Board of Mayor and Aldermen
July 18, 2024 Special Meeting @ 5:30 PM

Item #: 7.C. Approve Change Order #3 with Baron Construction, LLC for the Public Works and Community Development Services Facility.

This is a change order for the construction of the Public Works and Community Development Services Facility.

E303

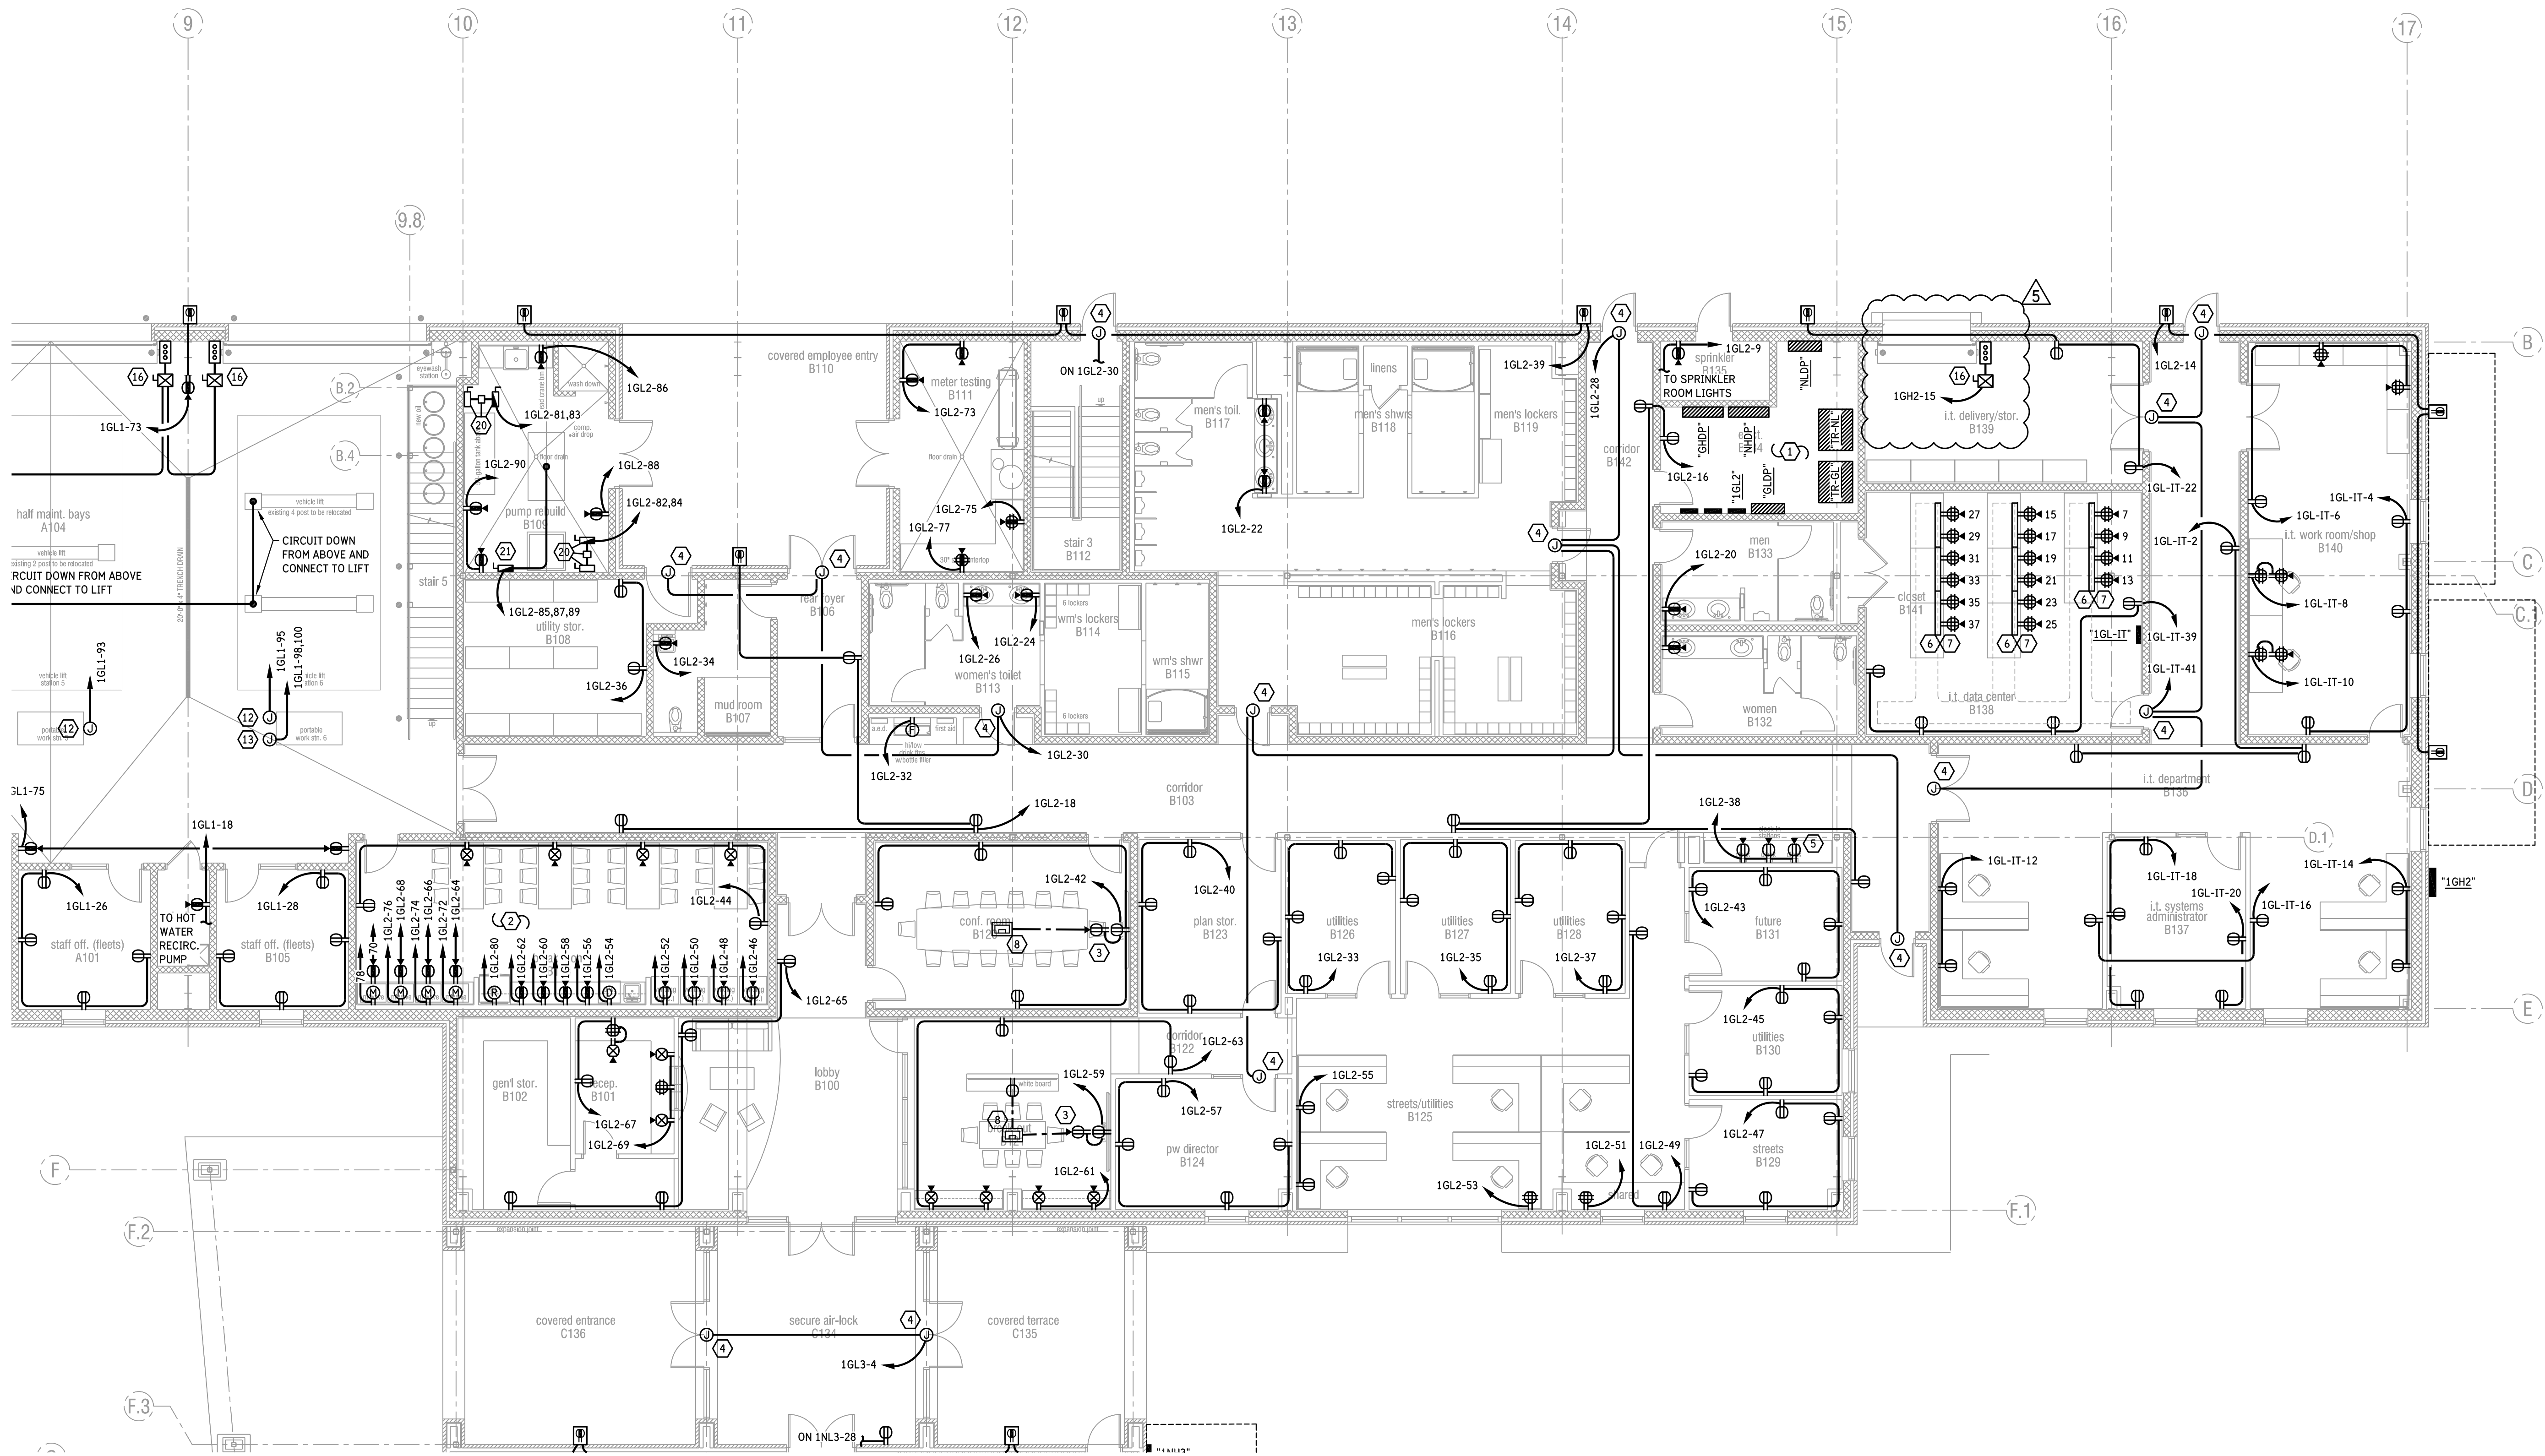
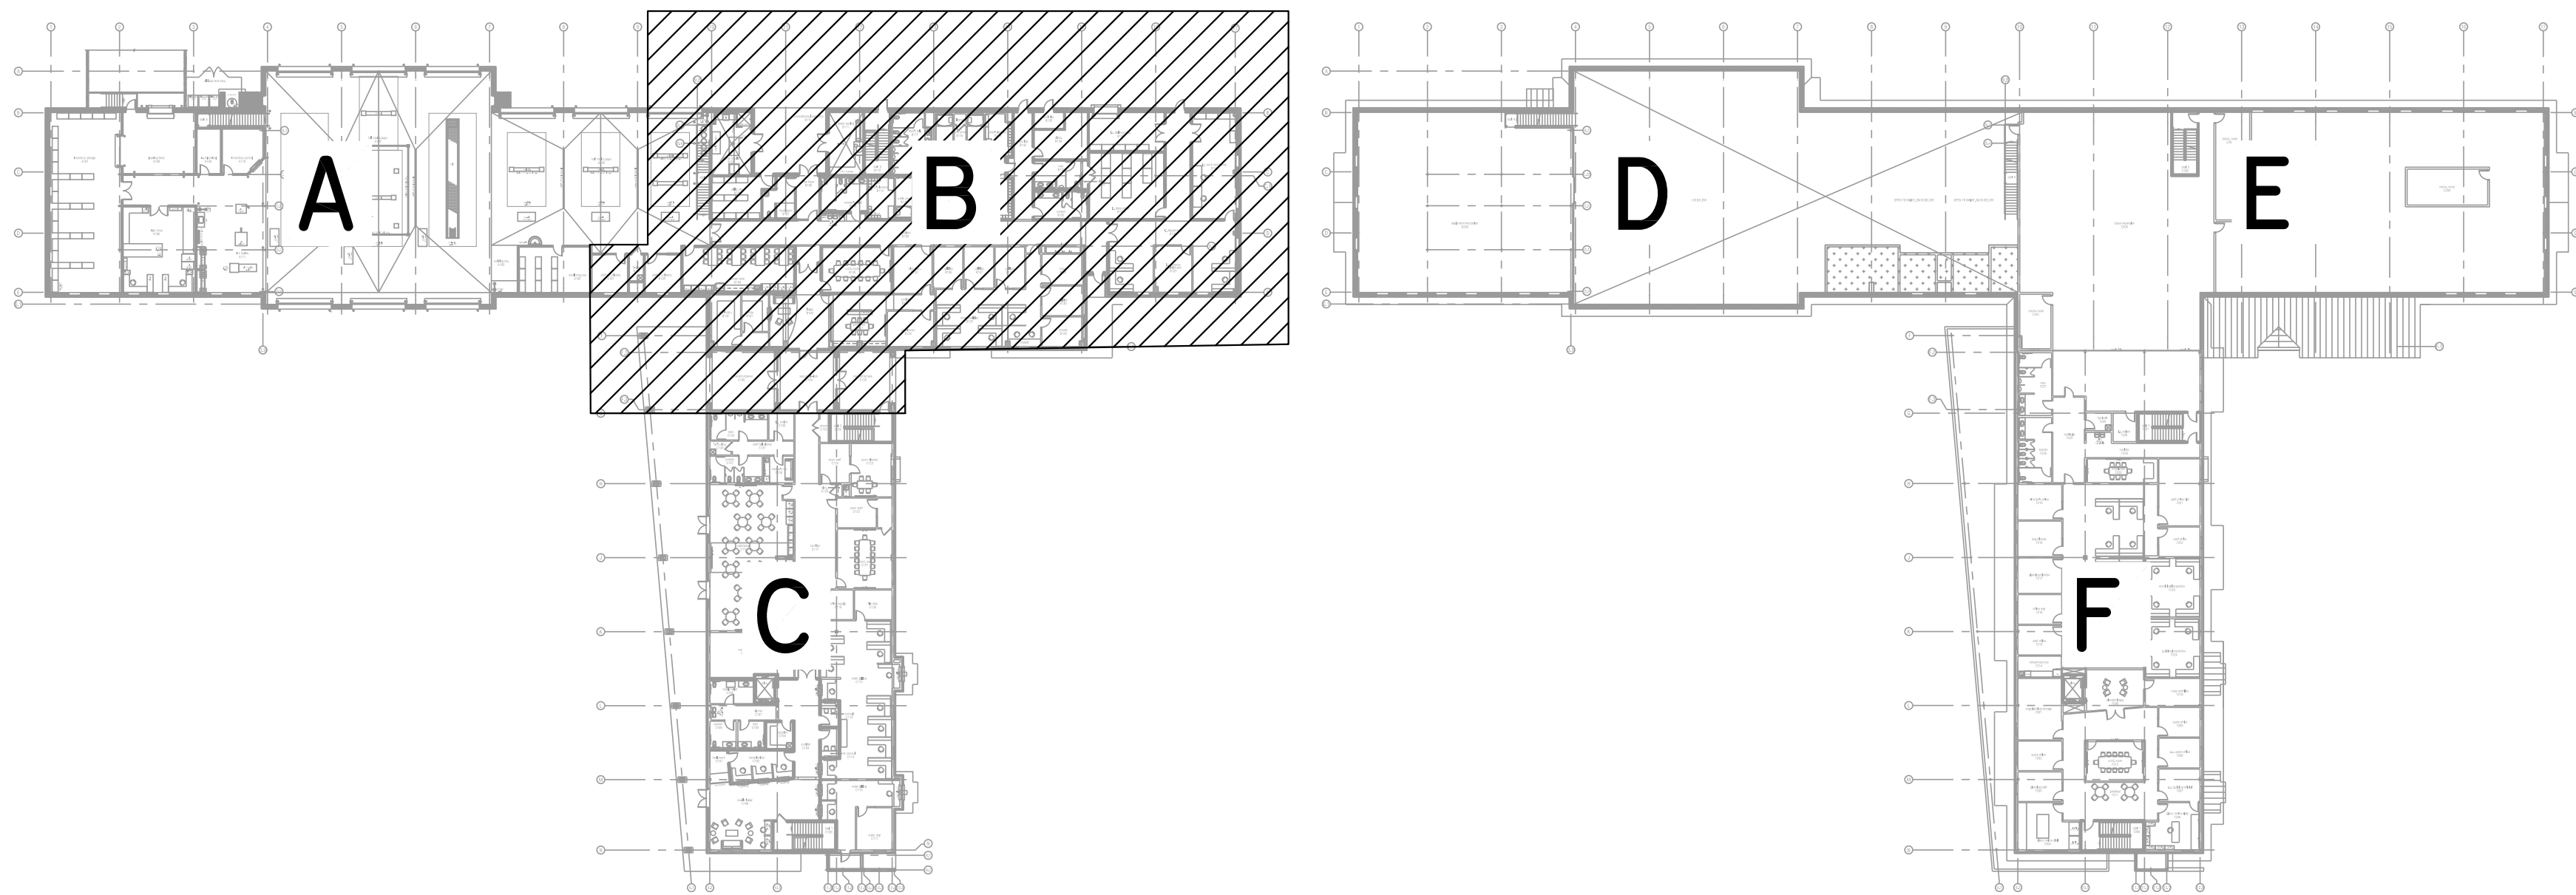
Question	Question from Roy Bruce Baron Construction, LLC on Thursday, Mar 21, 2024 at 02:18 PM CDT Tyler, The electrical drawings do not show power/circuits for the overhead doors at Exterior Vehicle Bldg 1 (sheet E308). Can you please send over a drawing showing the design intent for this? Also, per previous email correspondence can we please get a revised drawing(s) for Area A showing the circuits for the two overhead doors at Loading Dock A108 area (sheet E302). Attachments RE_ La Vergne PW - Dock Levelers _ Electrical Clarification.pdf
Official Response	Response from Tyler Ball Harpeth Park Engineering PLLC on Wednesday, Apr 3, 2024 at 09:27 AM CDT See attached revised drawings concerning the overhead doors. Narrative of changes: E302 Added overhead door connection for Inventory Storage A107. Revised overhead door connection in Loading Dock A108 for clarification. Edited Keyed Note 16 for clarification. E303 Revised overhead door connection in I.T. Delivery/Storage B139 for clarification. E308 Added overhead door connections for the Exterior Vehicle and Equipment 1 X100 shed. E702 Revised panel schedules per overhead door connections. Attachments E302 (ESD #5).pdf, E702 (ESD #5).pdf, E303 (ESD #5).pdf, E308 (ESD #5).pdf

E303 Revised overhead door connection in I.T. Delivery/Storage B139 for clarification.

Detail "9A"-
sides of CMU
Stair shaft

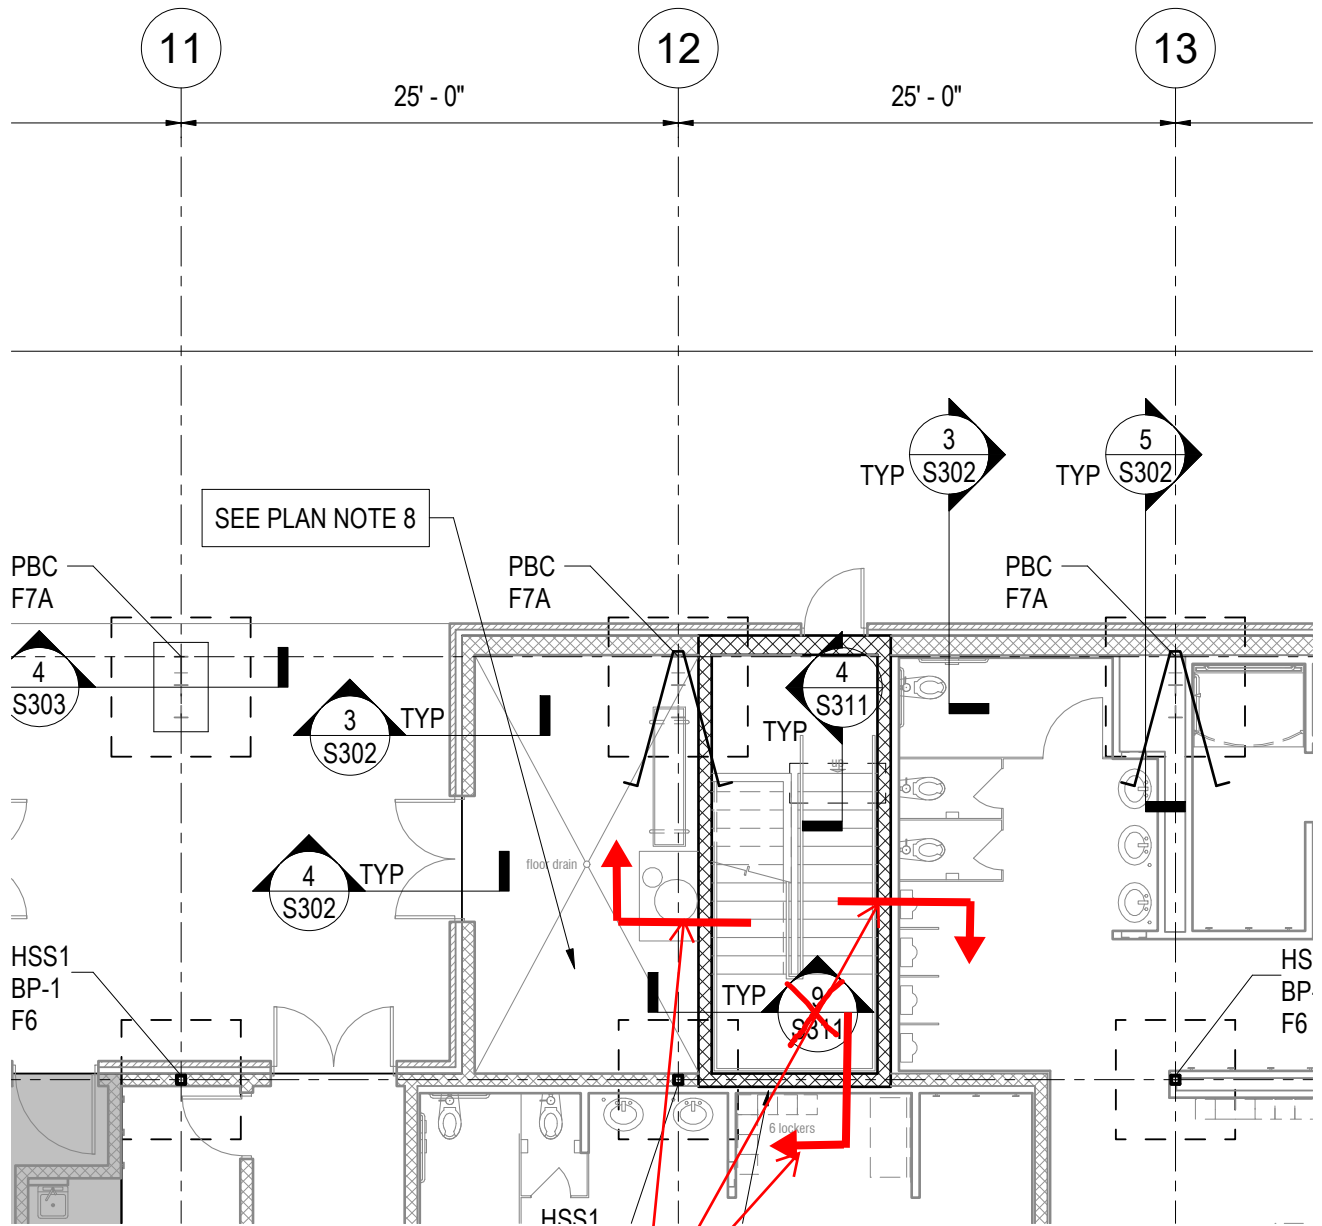
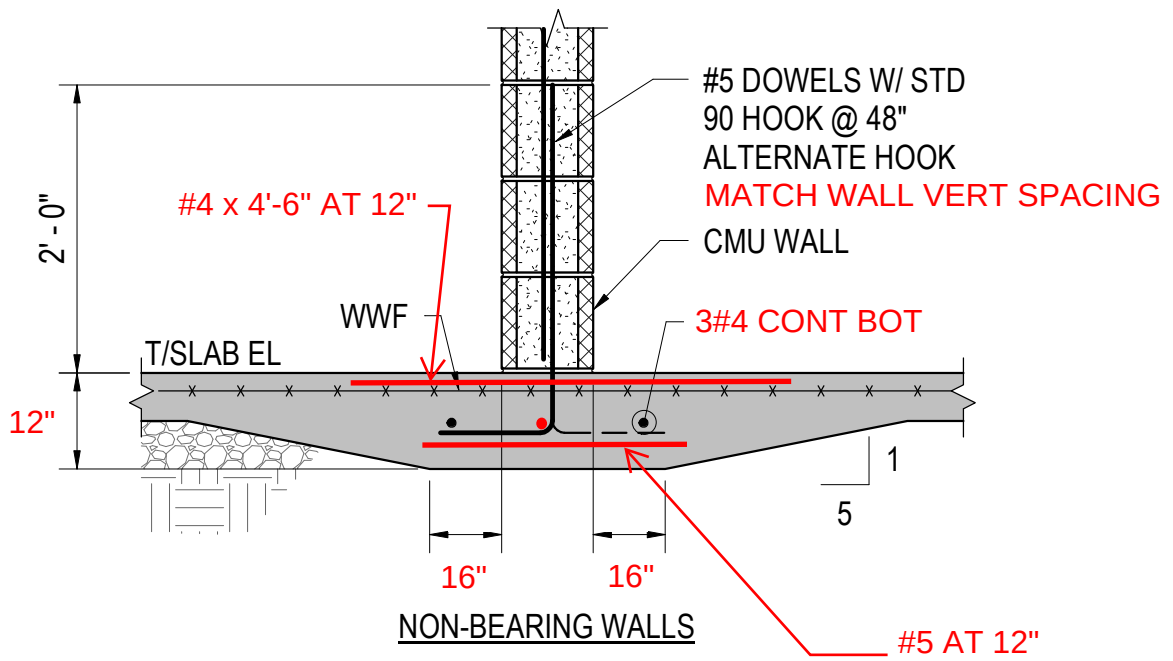
While reviewing the footing I noticed that we need to adjust the thickened slab supporting the stair CMU walls. These are two story CMU walls and support the stair landing. Please see the attached. Please let me know if you have any questions.

Footing modification at Stair 3 for CMU walls per Engineers instruction.
Two story CMU walls that support the landing, requiring thickened slab
detail modification at these CMU walls
